# ADDENDUM NO. 05 – PORTAGE PUBLIC SCHOOLS – CENTRAL ELEMENTARY SCHOOL BP 4: CONSTRUCTION

# ADDENDUM NO. 5 (BP4)

PROJECT: Central Elementary School Bid Package 4: Construction

ARCHITECT'S PROJECT NO.: 21-237.10

SHEATHING ON 8" CFMS -

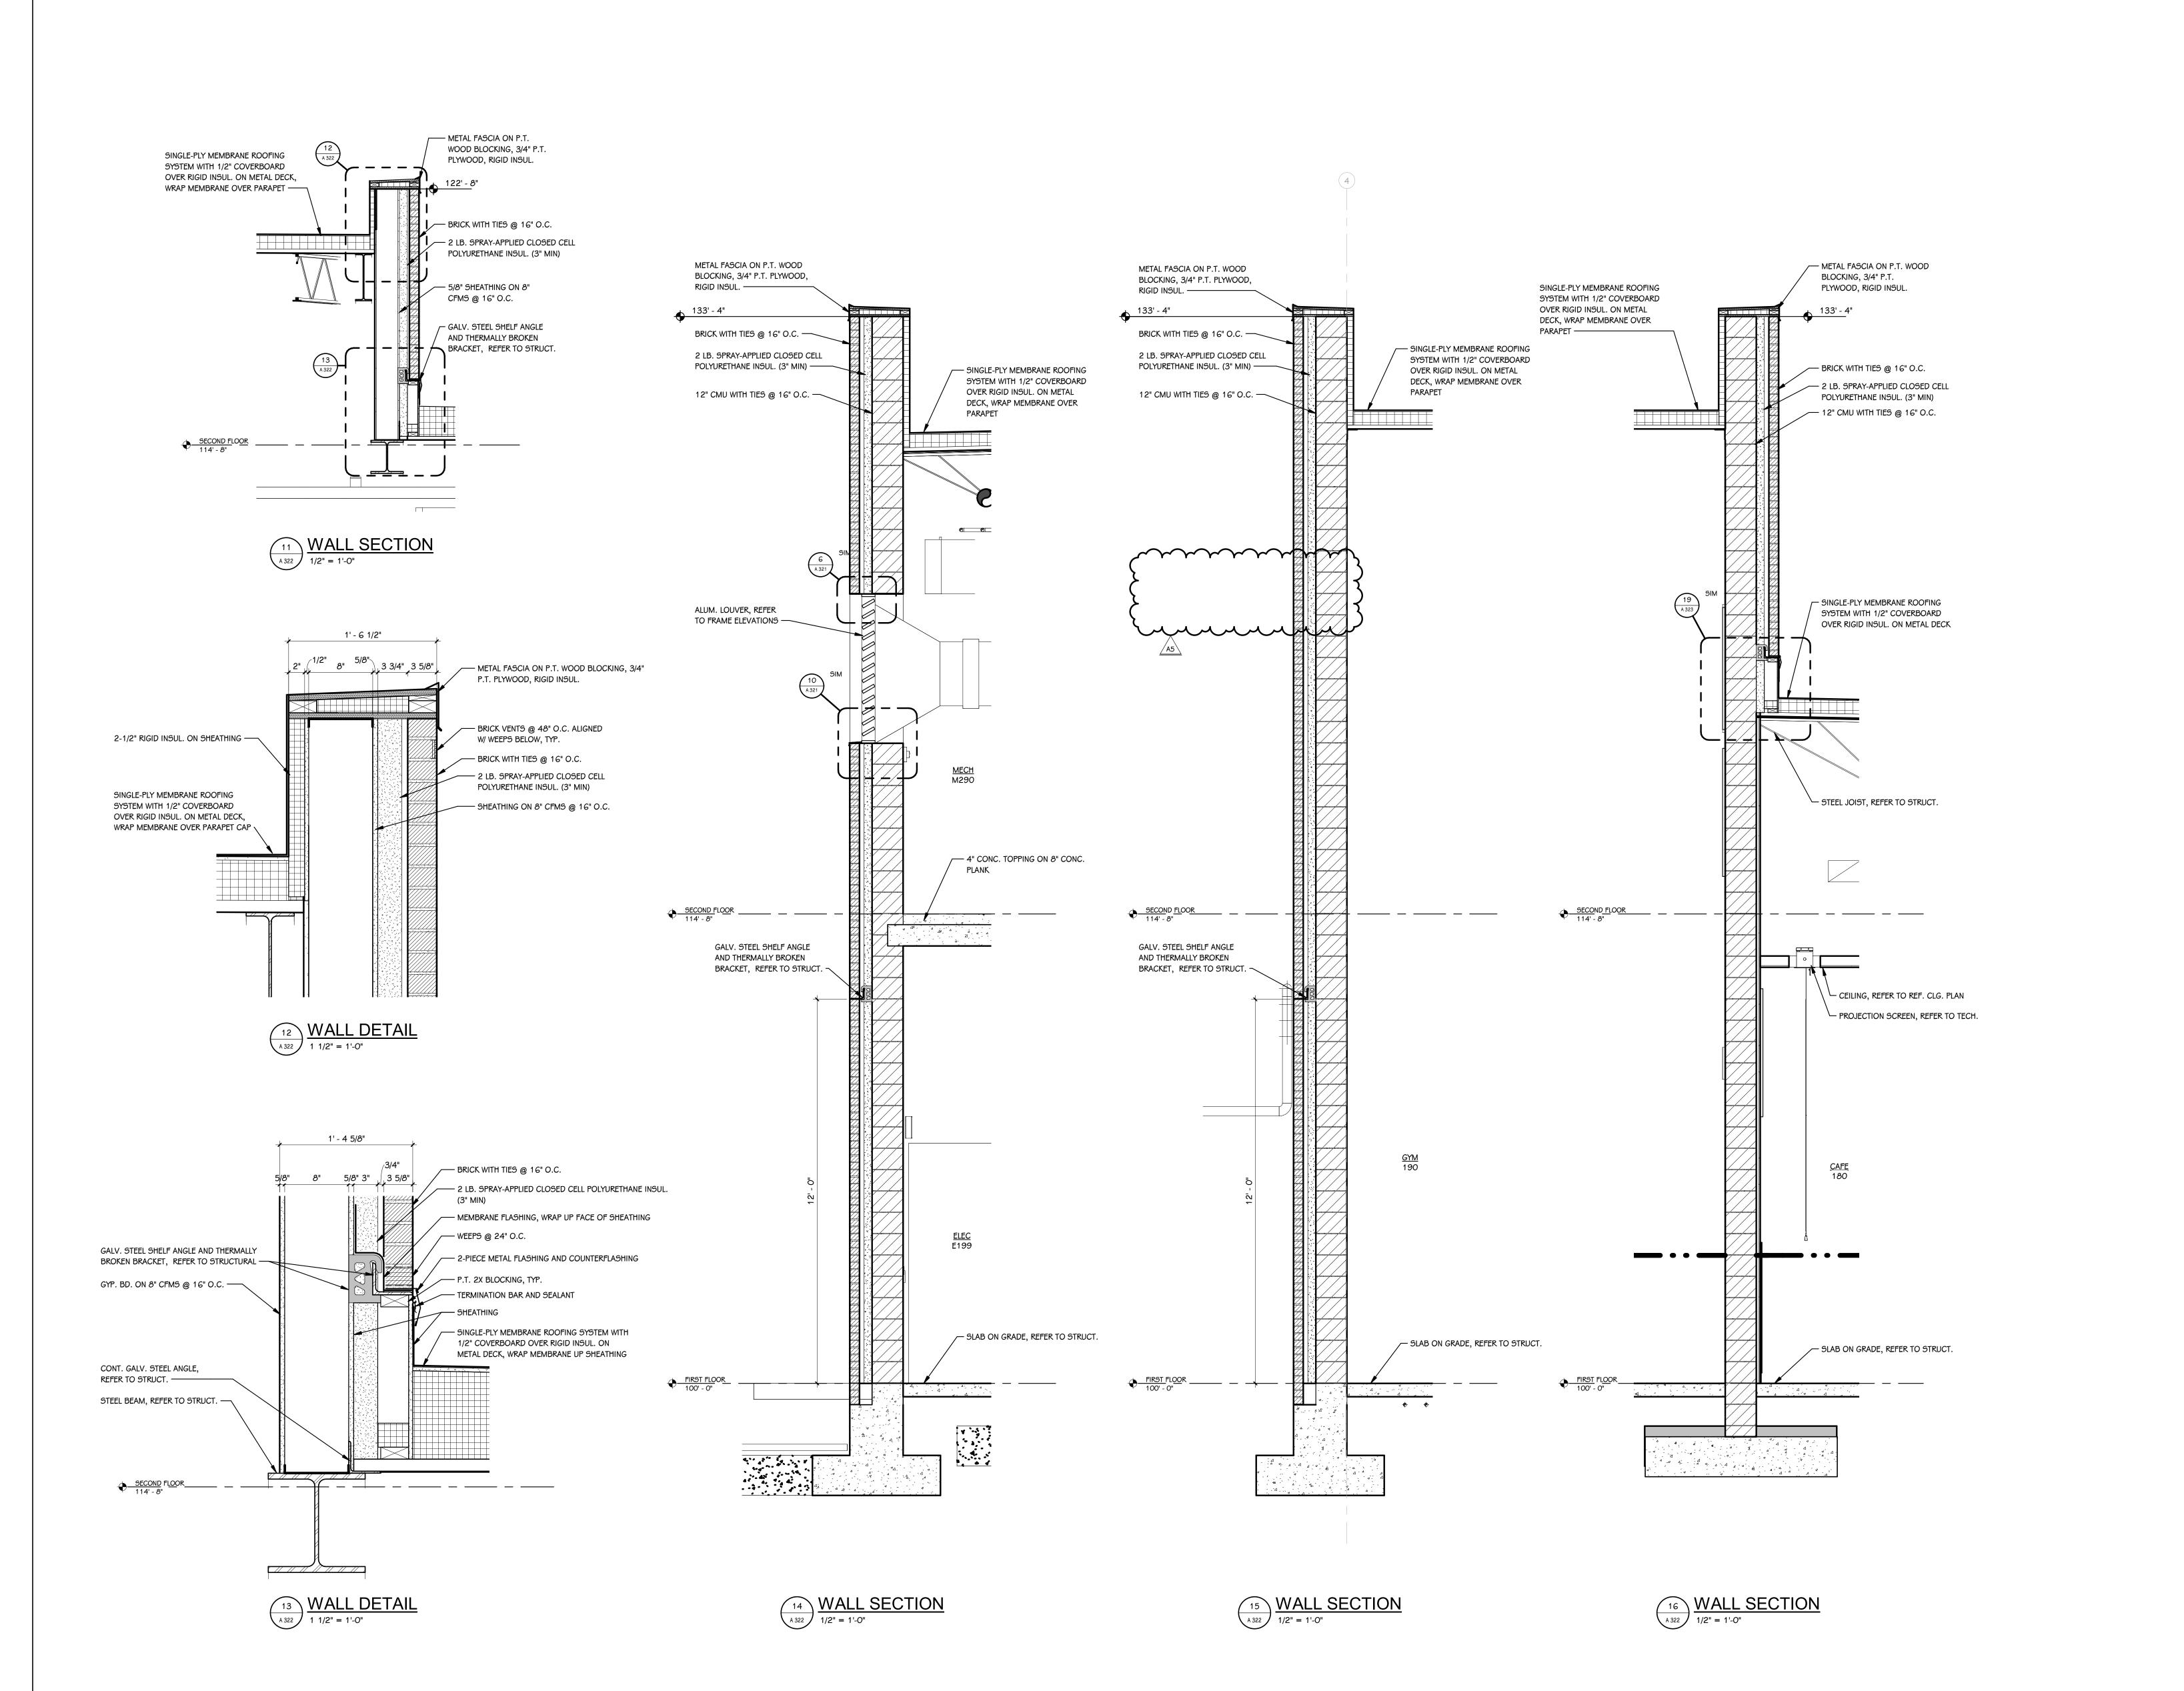
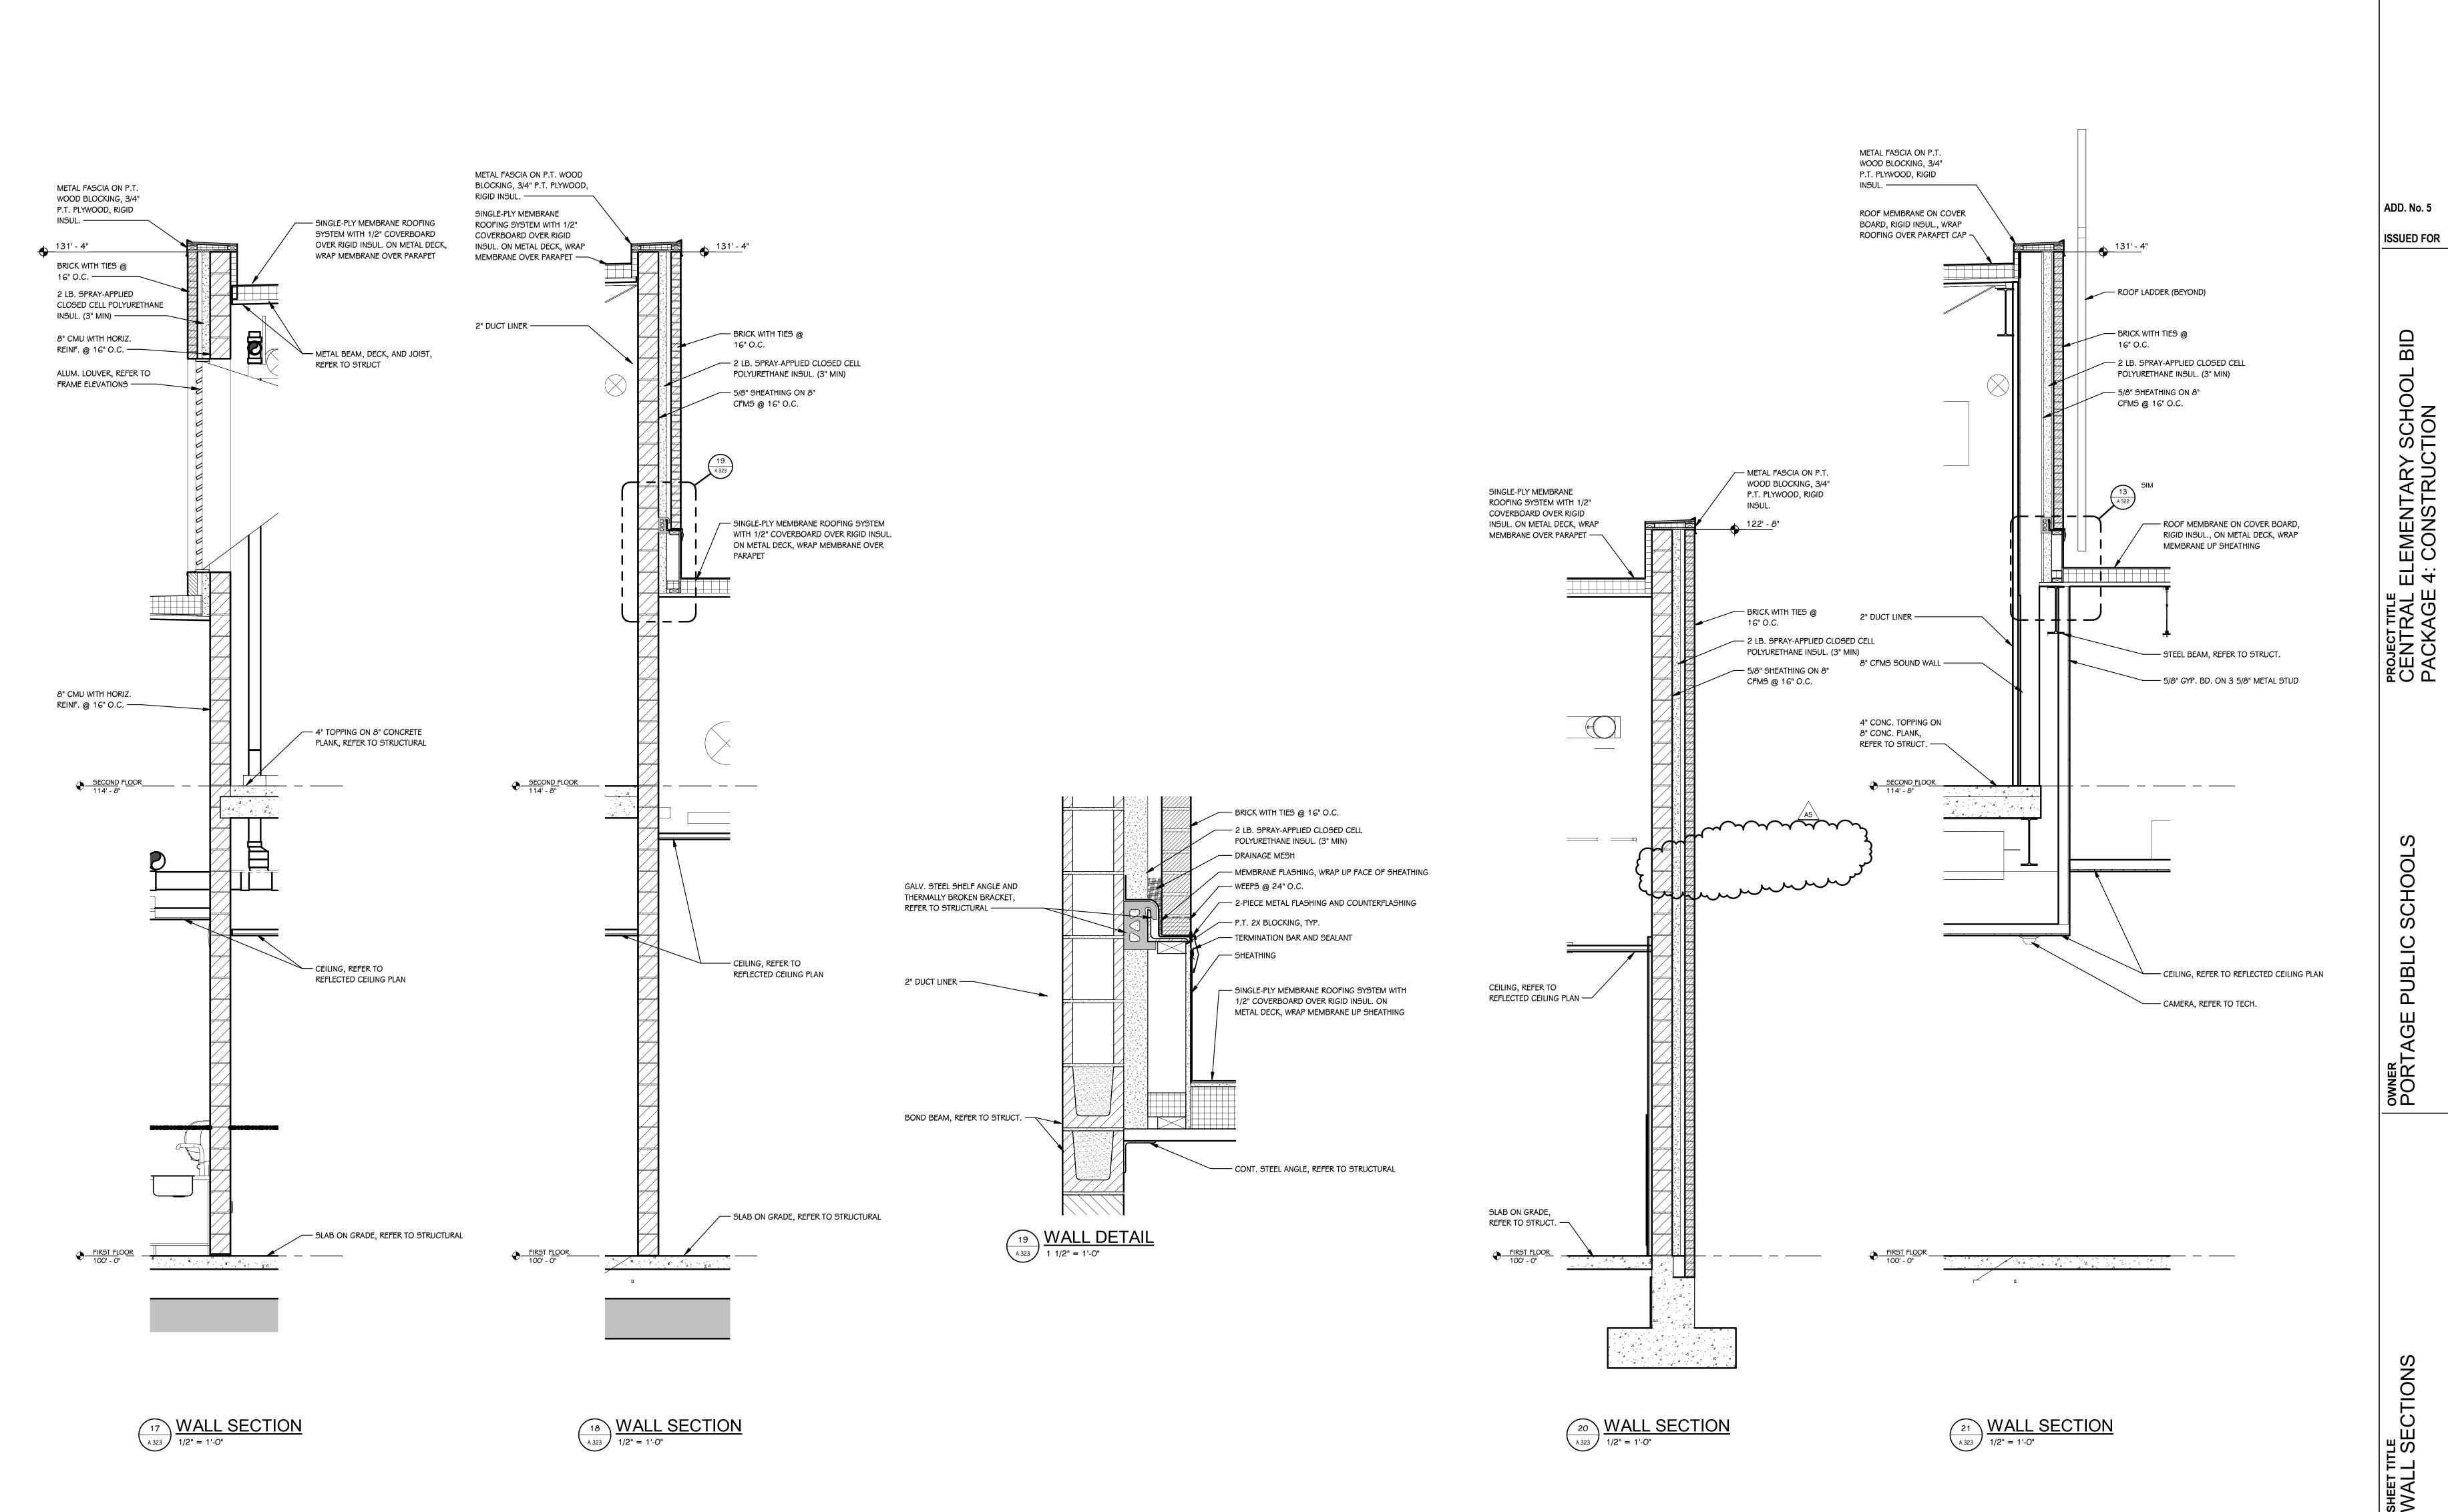
#### ADD-5 Item No. D-7 - Thermal Brackets at Veneer Bearing

Fero Fast thermal bracket detail updated. Thickness of continuous shelf angle is revised.

Revised wall sections to remove shelf angle and bracket in alignment with 2<sup>nd</sup> floor openings. Revised shelf angle and bracket note, added typical note to 1/A321, provide membrane flashing, cavity drainage mesh, weeps and vents at shelf angle [12'-0"h locations].
